# **ADMINISTRATIVE AMENDMENT**

FILE #: SI-2023-01718 PROJECT #: PR-2019-002677

Modifications to approved site plan phasing, building elevations, and landscaping;

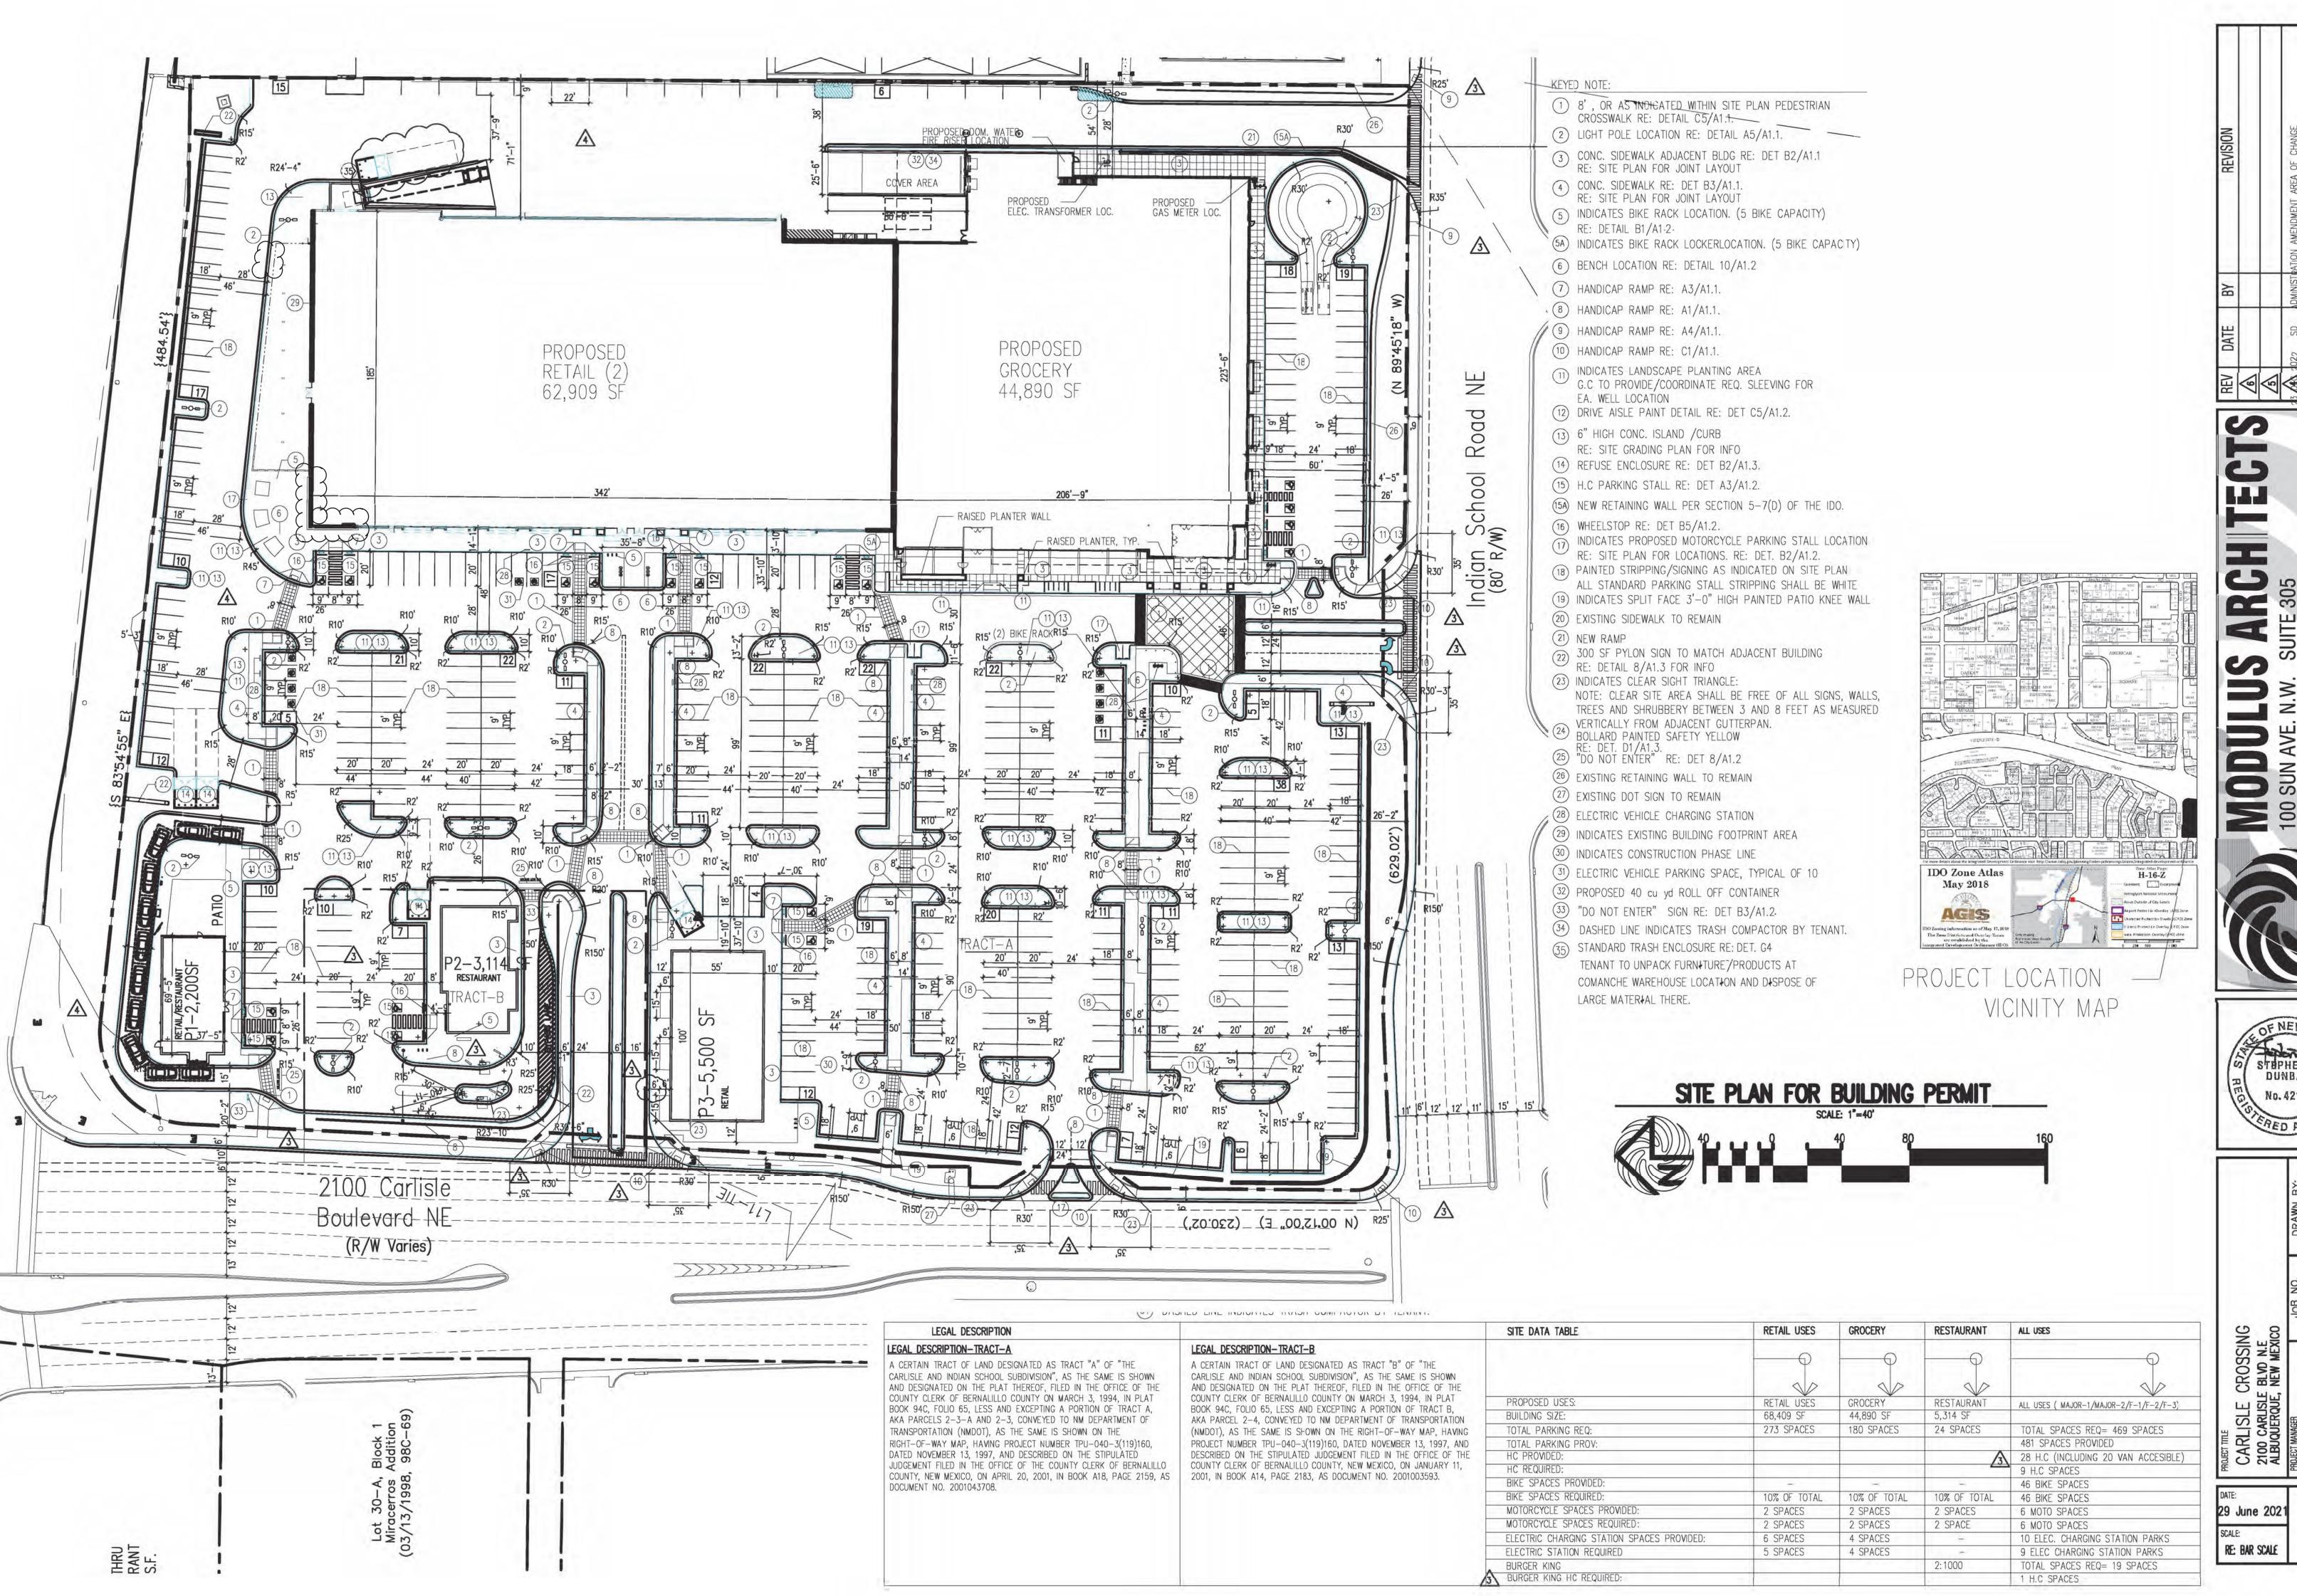
Outdoor patio (3,888 sf) north of the retail use changed to phase 2; Removal of patic

No changes to site access, circulation, or parking.

WEST ELEVATION

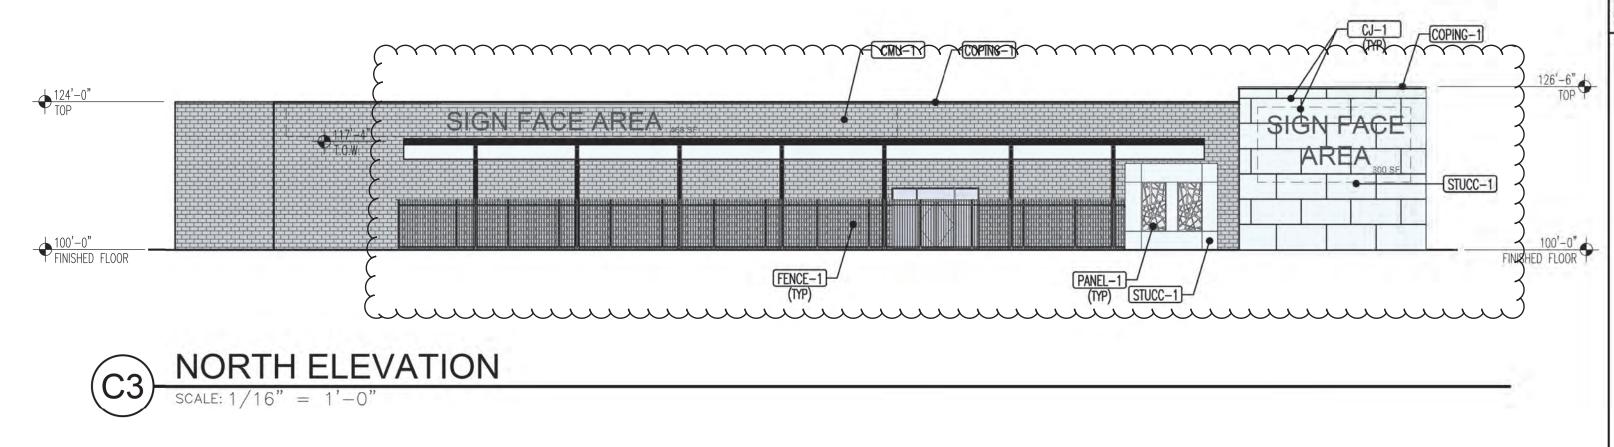
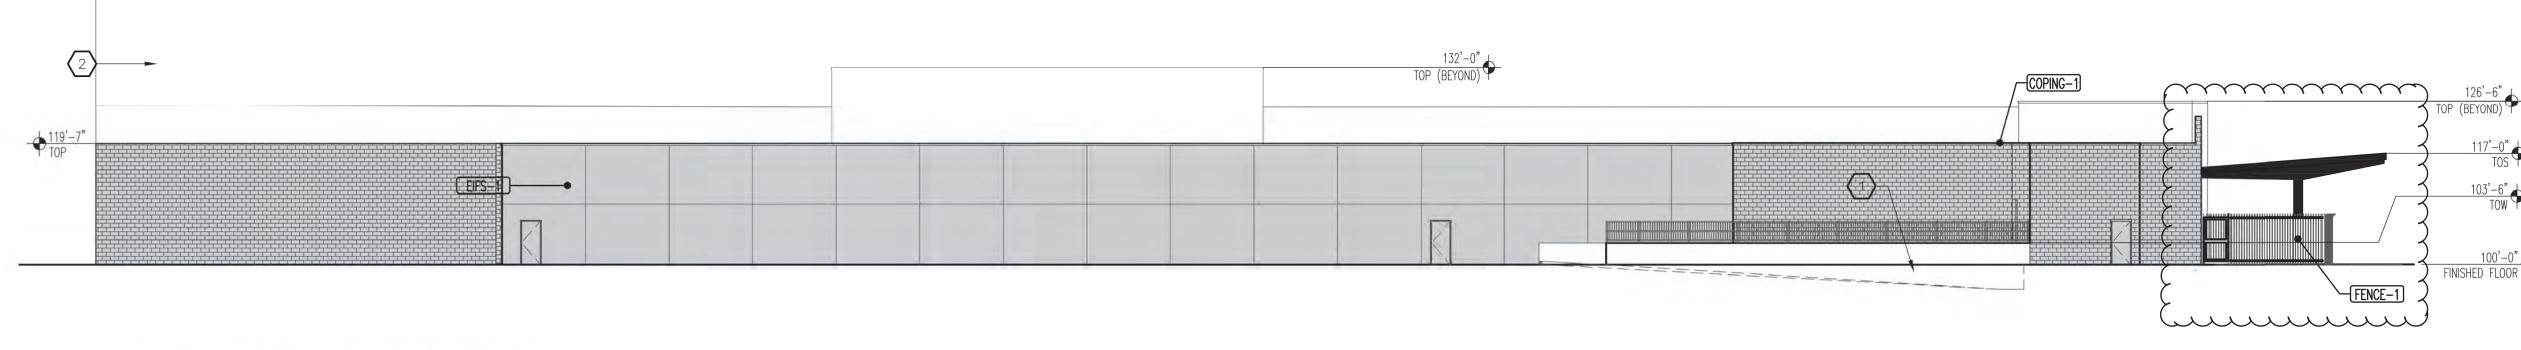
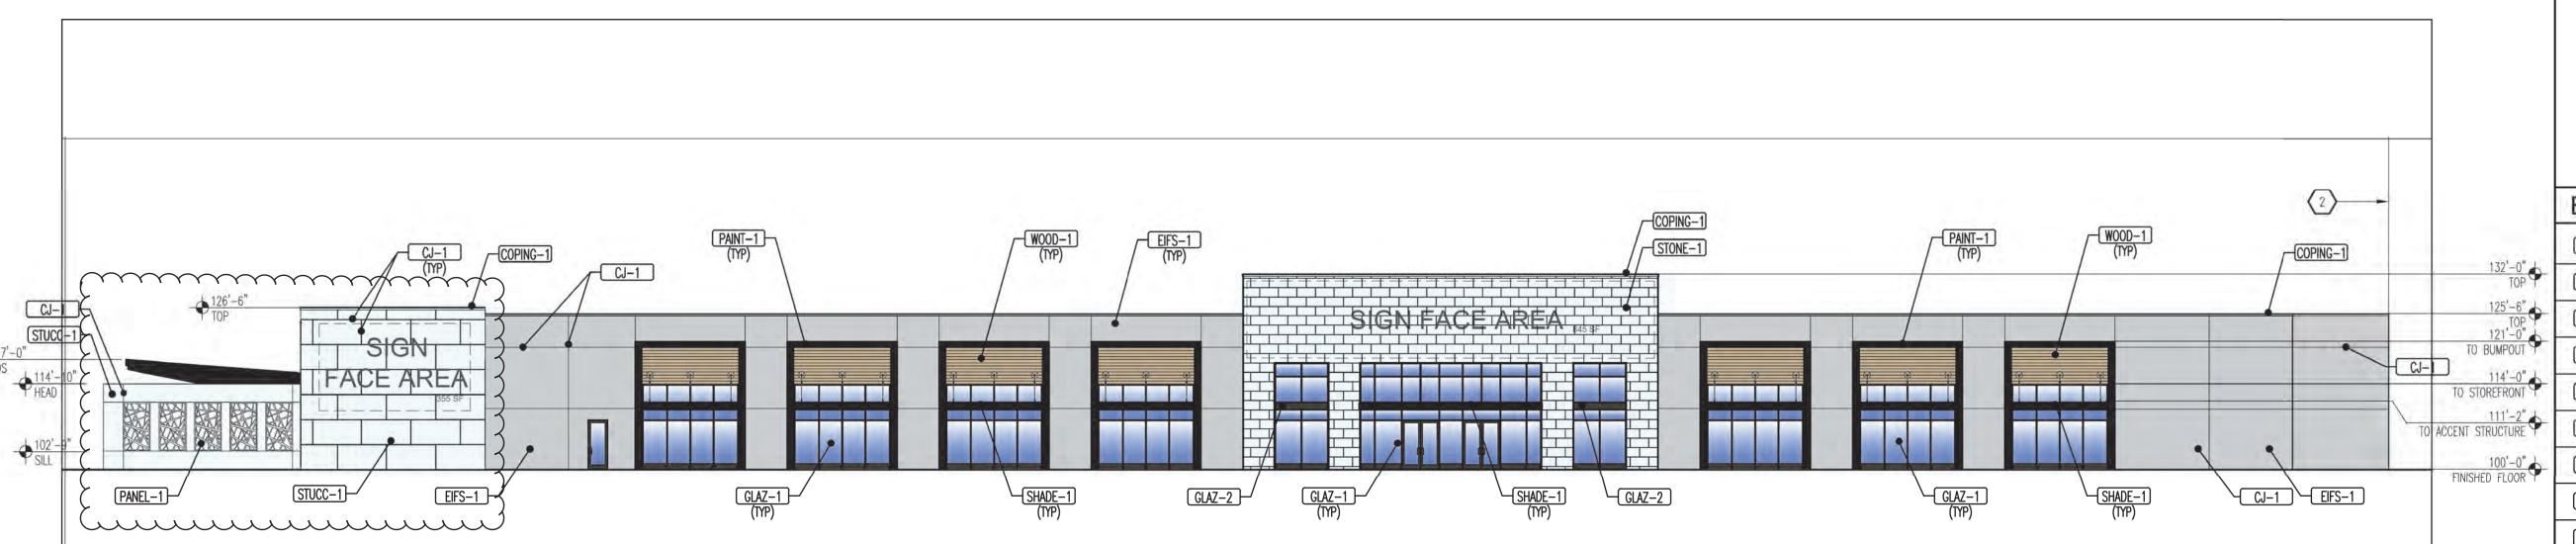
Elevation modifications to NW corner of American Home retail pad: Glazing removed

Landscape Plan

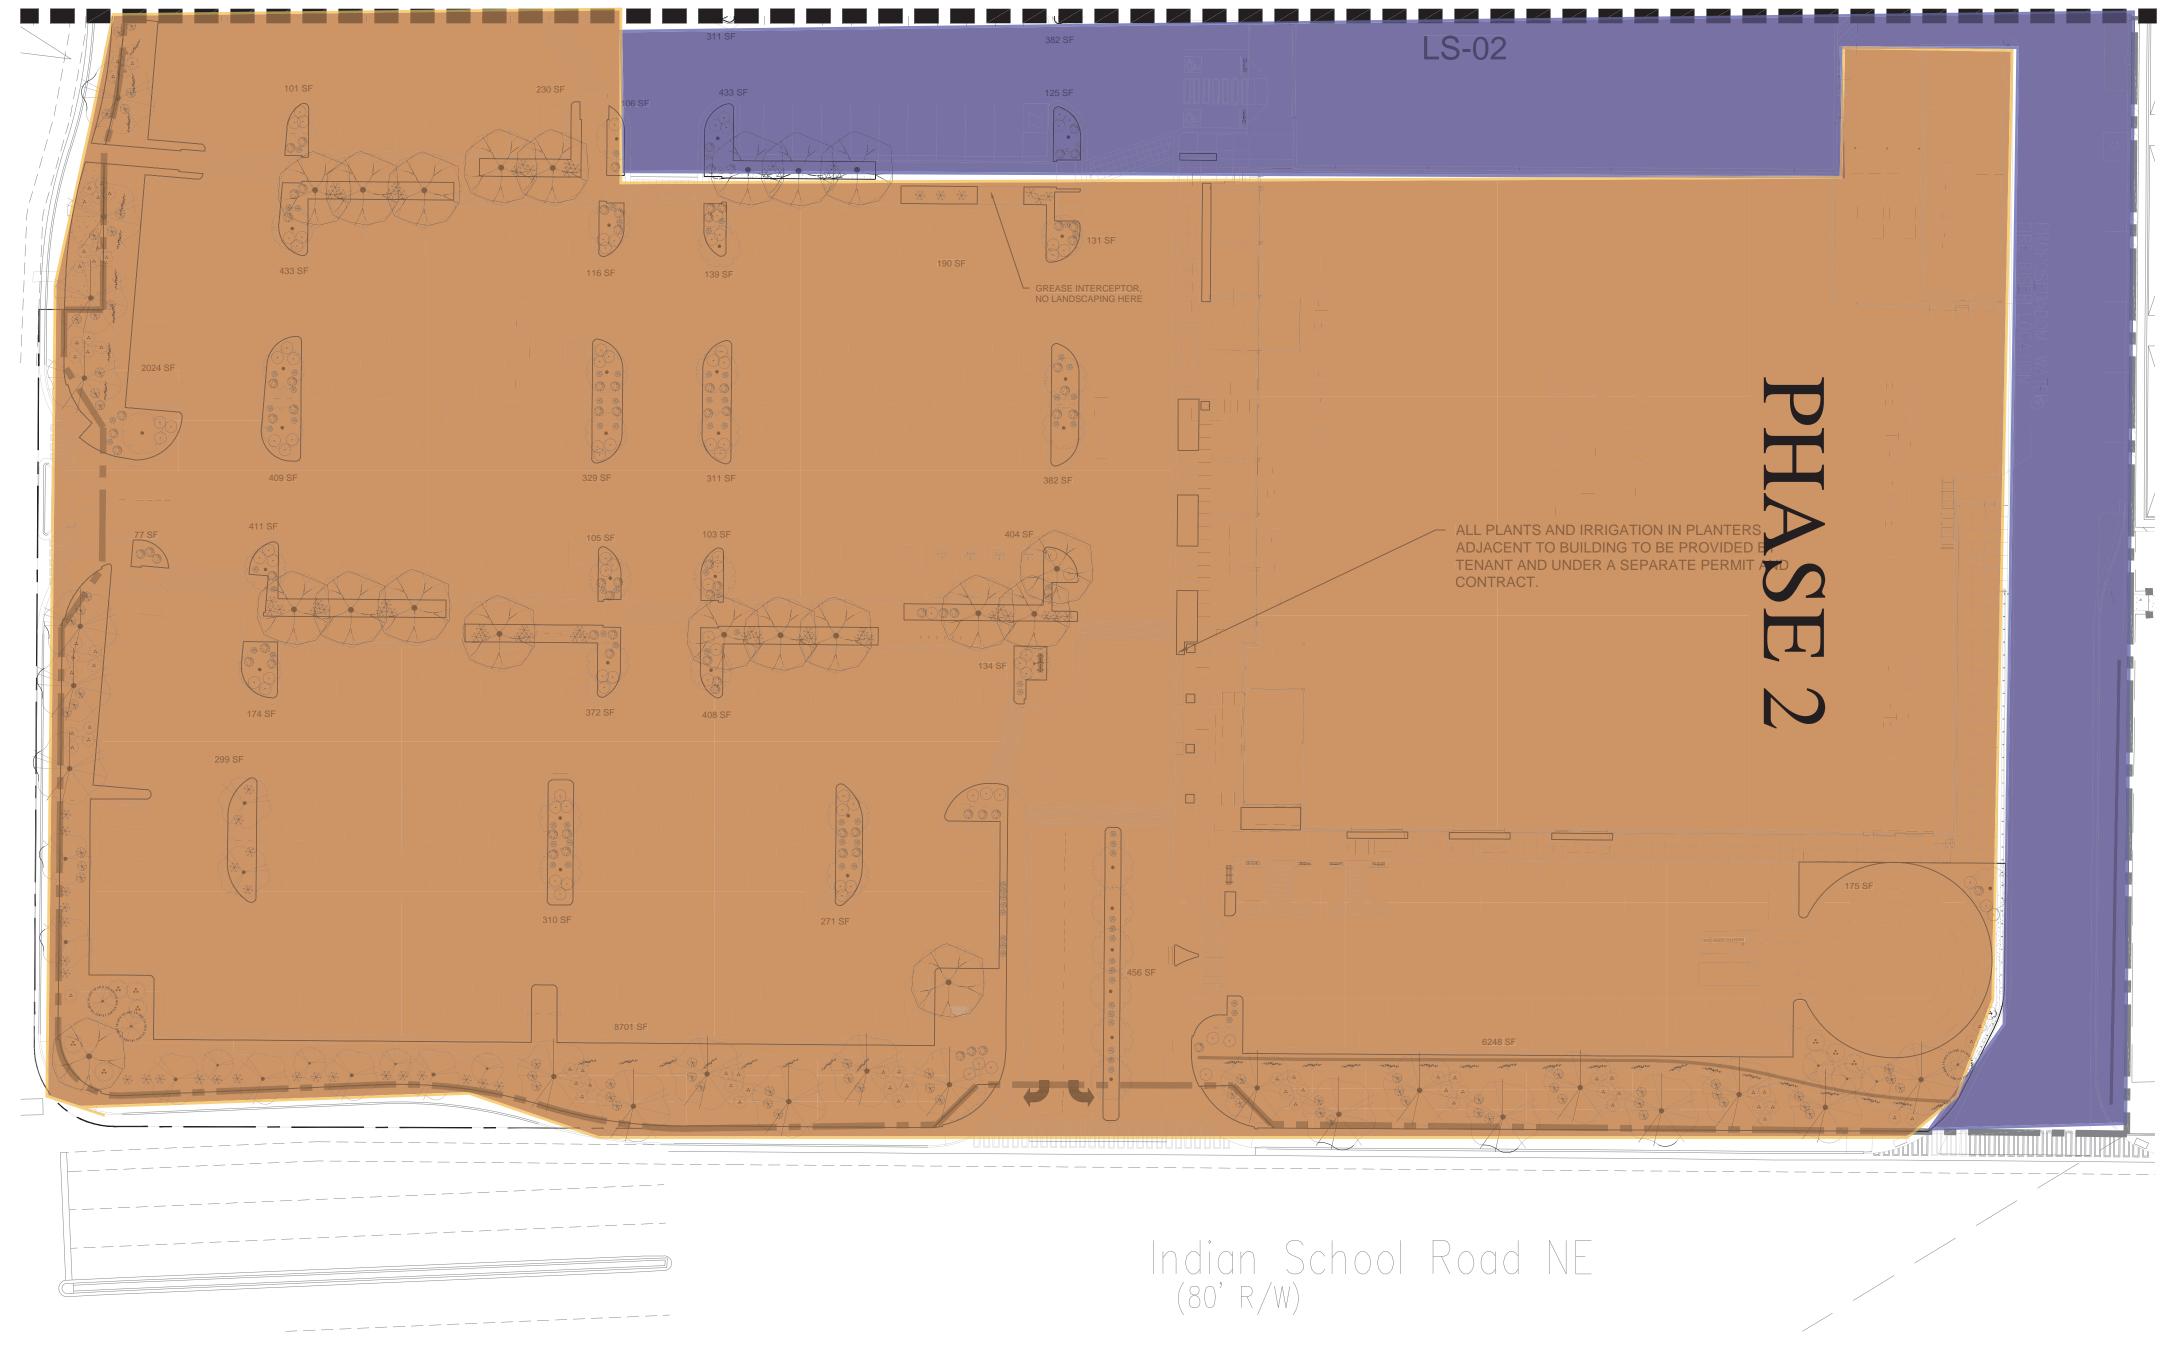
Landscape plan modified to accommodate site changes. All changes compliant with
